RECORD COPY of ASI-018, included as  
3 of 6 ASIs for reference with SPA-03

PROJECT NAME:	One River Run (Kindred) 75 Hunki Dori Ct. Keystone, CO 80435	ASI #:	018	<input checked="" type="checkbox"/> OWNER <input checked="" type="checkbox"/> ARCHITECT <input type="checkbox"/> CONSULTANT <input checked="" type="checkbox"/> CONTRACTOR <input type="checkbox"/> FIELD
PROJECT #:	117033	DATE OF ISSUANCE:	04/15/2024	
OWNER:	One River Run Acquisition Keystone Investments, LLC 132 West Main Street, Suite D Aspen, CO 81611	ARCHITECT:	OZ Architecture, Inc.	
		TO CONTRACTOR:	PCL Construction Services, Inc	
		CONTRACT FOR:	GMP/Building Permit Resubmittal	
		CONTRACT DATED:	September 23, 2021

DESCRIPTION: This ASI provides updated Architectural drawings to remove the Plaza Lift (Keynote 14.01) in the vicinity of the monumental stair on the South side of Area D and to change access and control as required to provide an alternate Accessible Route between the Gondola Plaza on L0 and the Public Courtyard on L1 through the Hotel portion of the project. These changes are being made at the request and direction of the Owner. Architect has confirmed with the AHJ that removing the lift is allowable by Co

ONE RIVER RUN  
ISSUED FOR:  
GMP / BUILDING PERMIT RESUBMITTAL  
SHEET TITLE:  
LEVEL 1 FLOOR PLAN - OVERALL  
SCALE: 1/16" = 1'-0"  
SHEET NUMBER  
**A-101**

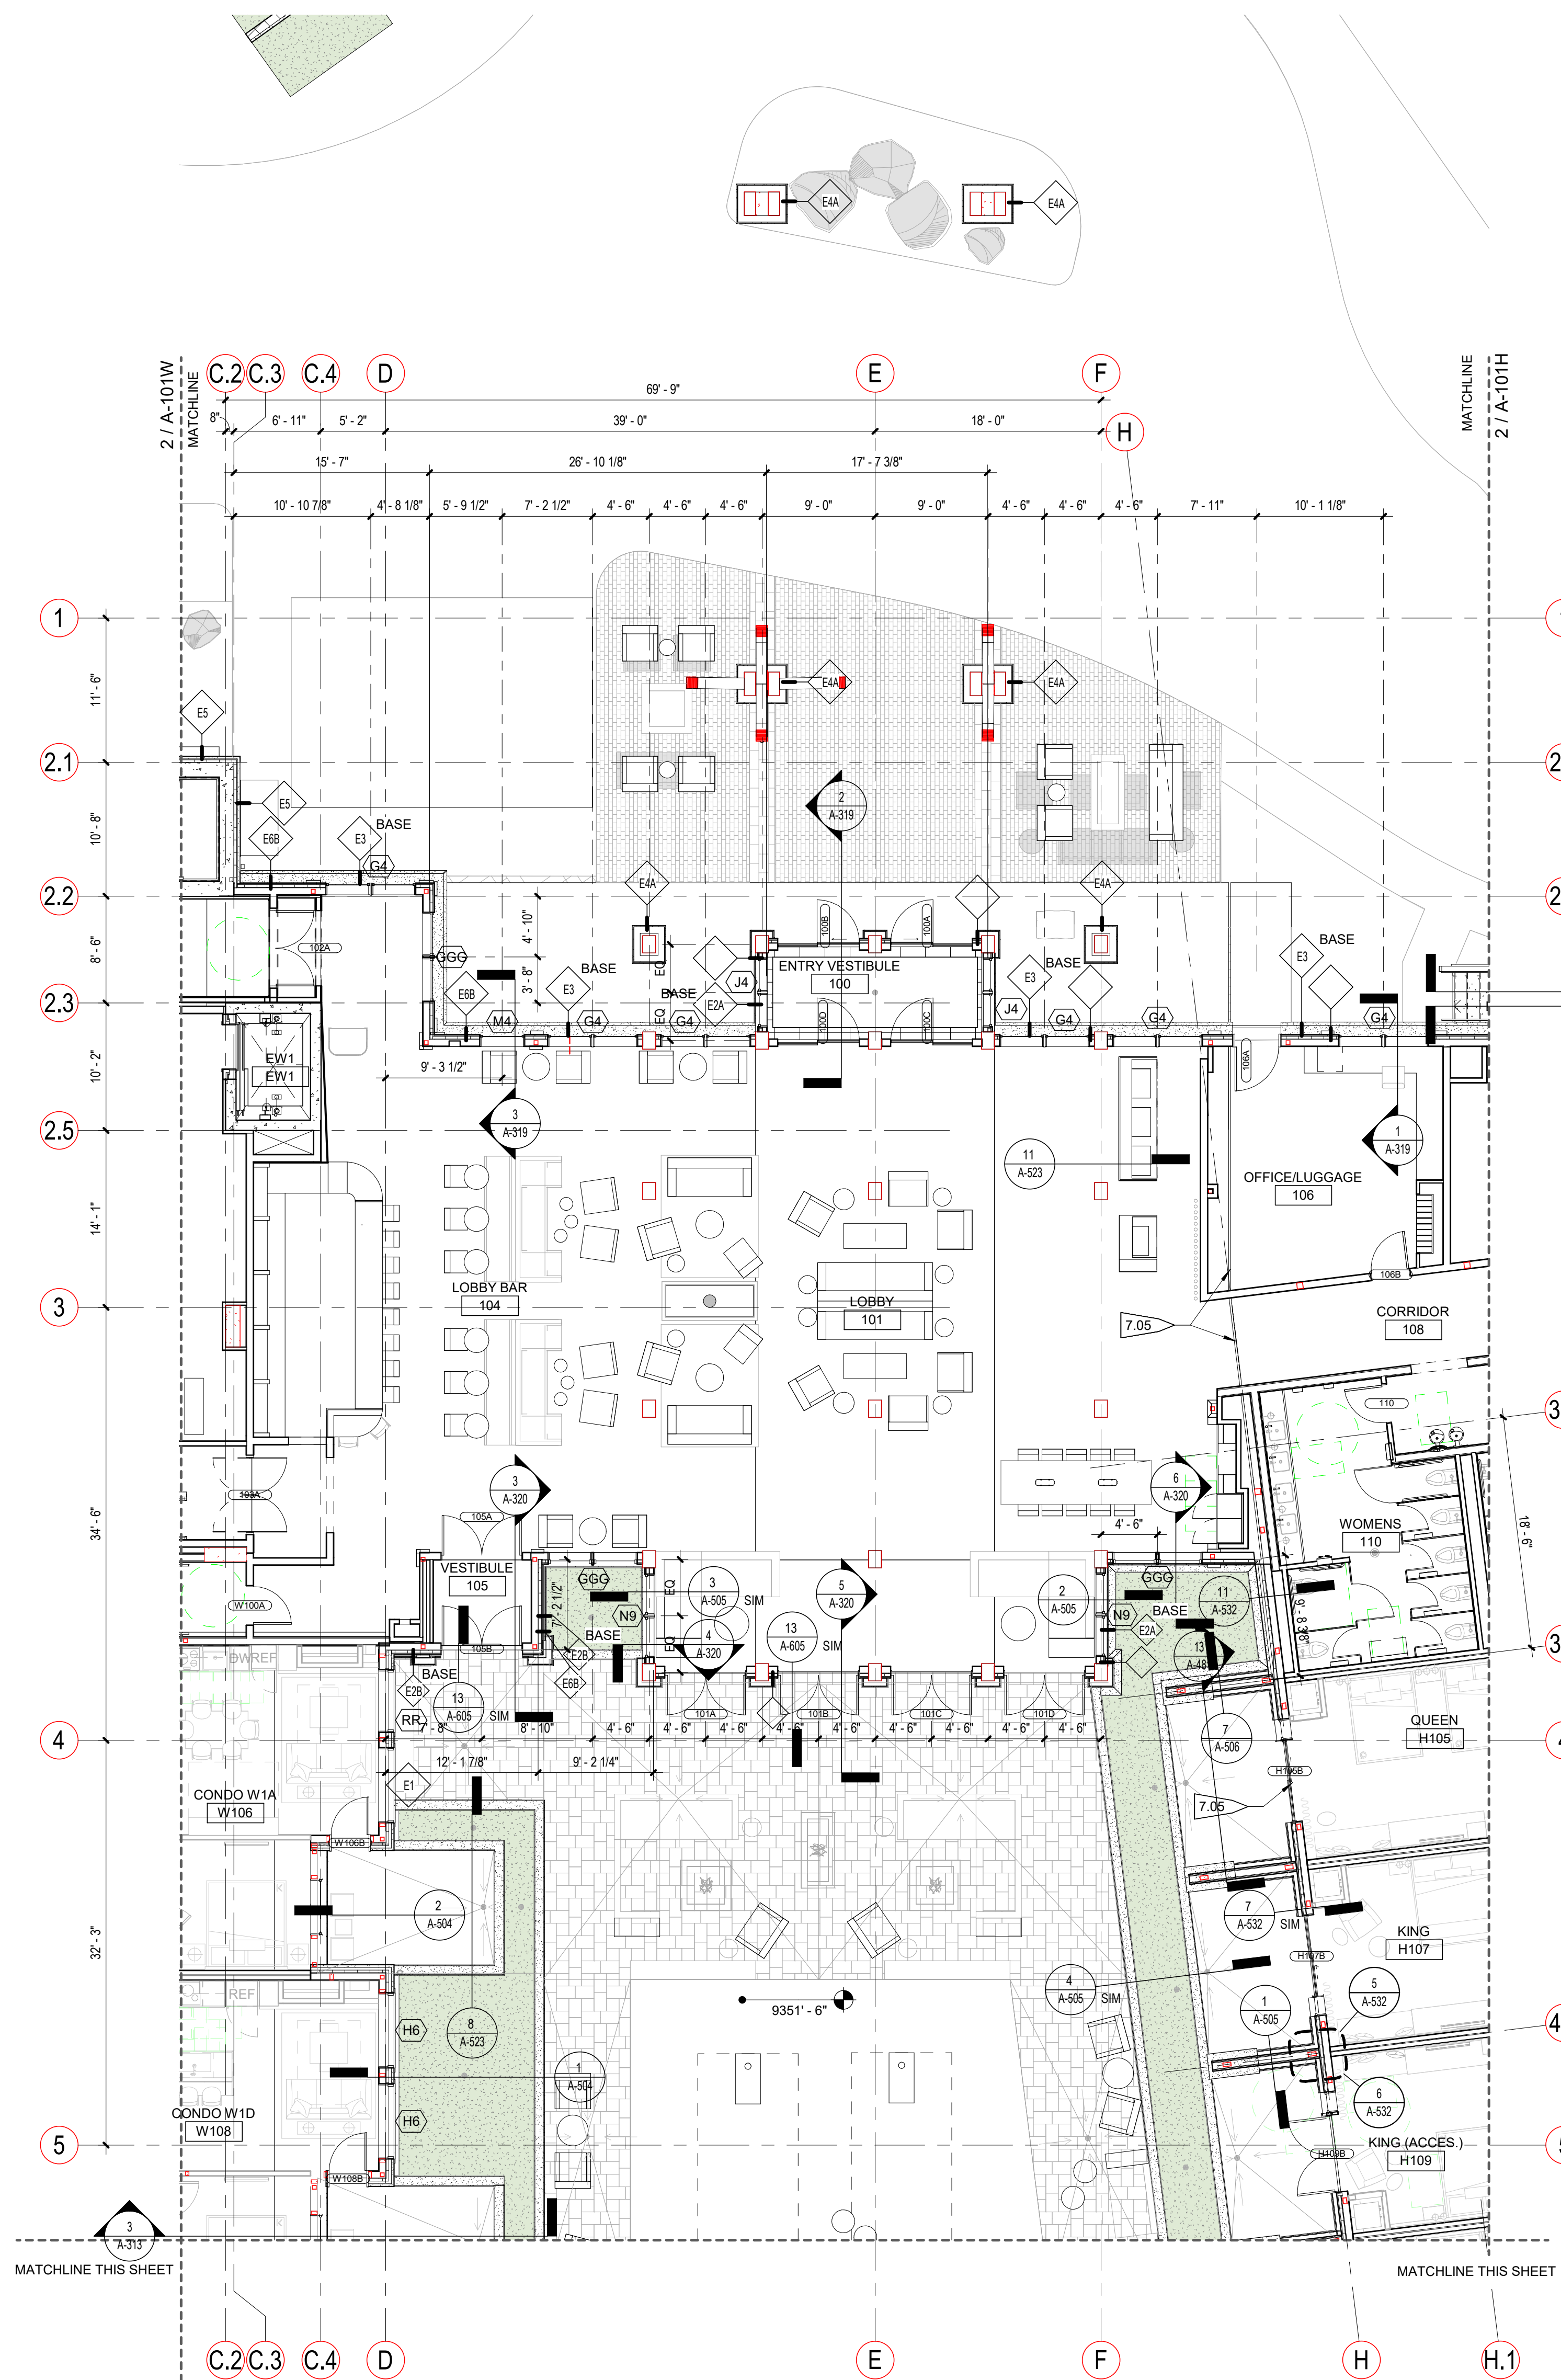
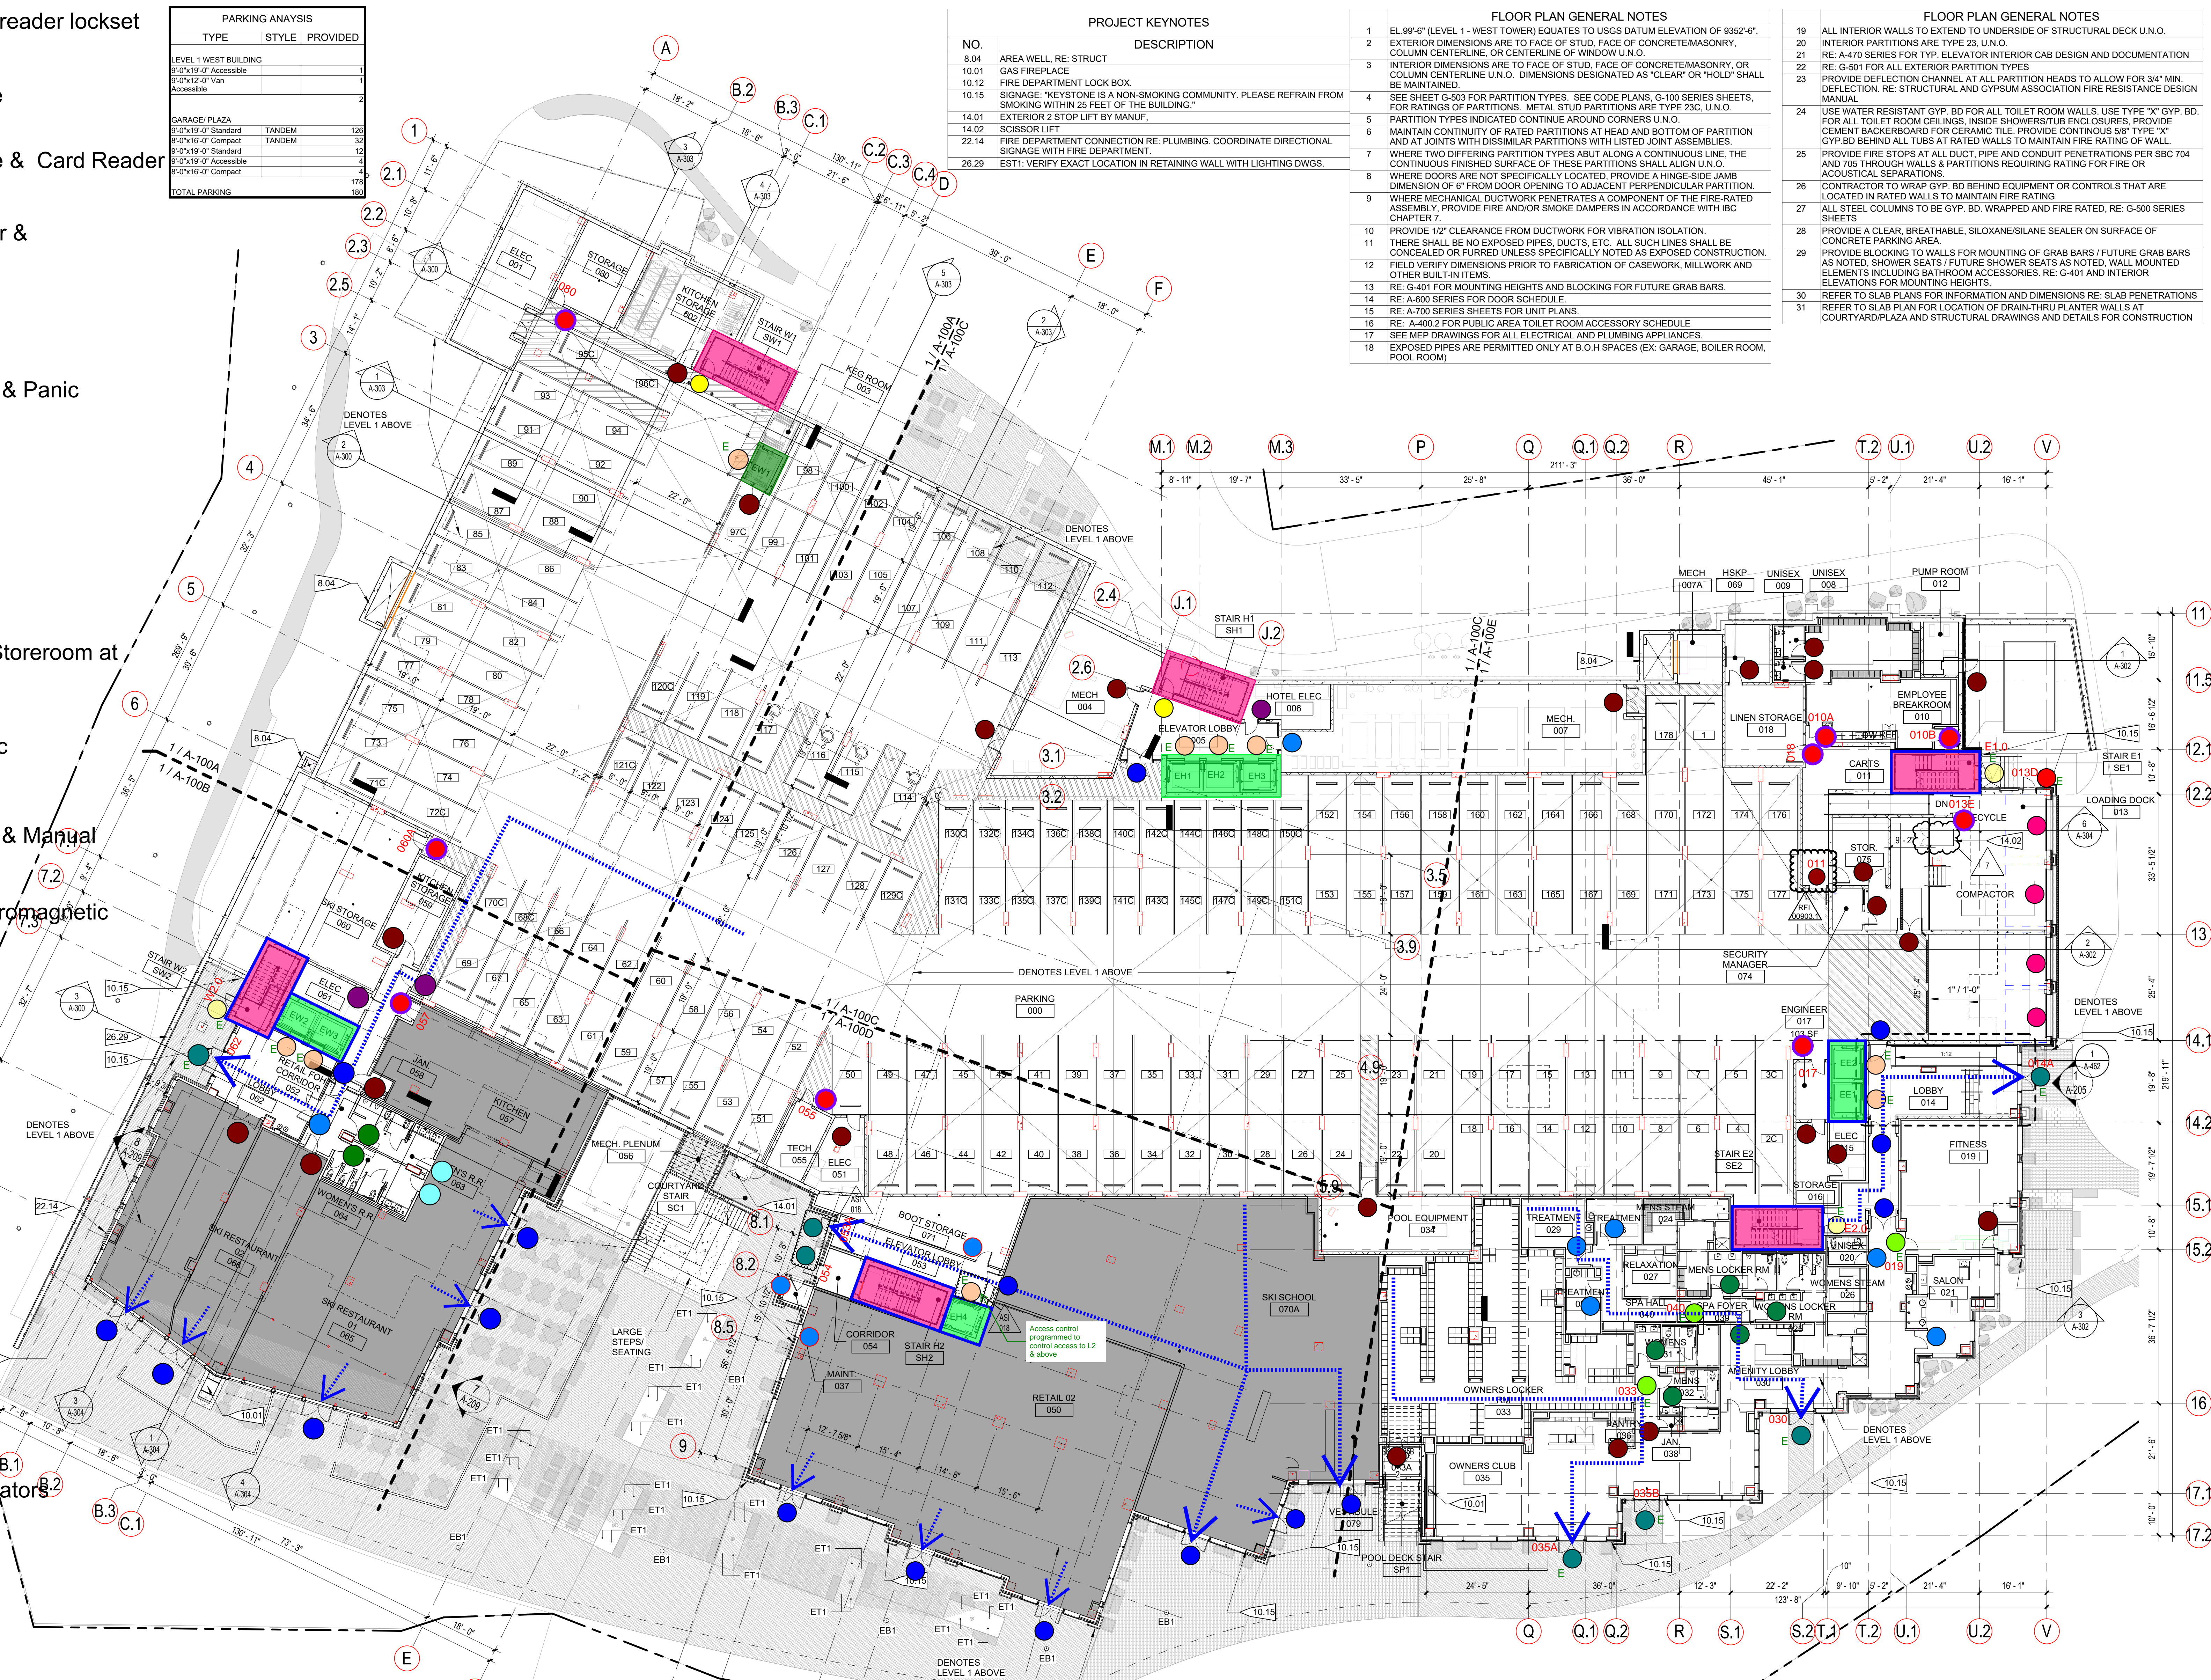
As referenced above, operationally, this ASI will necessitate modifying the hardware at Doors 053A, 054 and H100B to allow public access to elevator EH4 on Levels 0 and 1 respectively. Additionally, signage identifying the Accessible Route for public use is provided from Level 0 to Level 1 and vice versa as shown in the attached plans.

- 2.1 Change Elevator control at EH4 so that this elevator is available for public use from L1 to L0 (only) at all times; card reader may remain to control access to L2 and above.
- 2.2 Add Accessible Route signage on interior wall adjacent to Elevator EH4
- 2.3 Change hardware on Door H100B so that this exterior door remains unlocked (no card reader) at all times.
- 2.4 Add Accessible Route signage on exterior wall adjacent to Door H100B
- 2.5 Remove ADA Lift (Keynote 14.01) and associated structural infrastructure. (Same as Item 1 above)
- 2.6 Change handrail/guardrail to continuous where ADA Lift has been removed (Add approximately 4 L.F.)
- 2.7 Add Accessible Route signage on exterior partial height wall adjacent to top of Monumental stair.

**NOTE:** No changes required to Door H100C or Pool Gate 1PB specifically because these openings are not on a required path of egress.

This will allow operator to limit access to the Pool Deck area to Guests Only by way of a card reader on the inside of Door H100C.
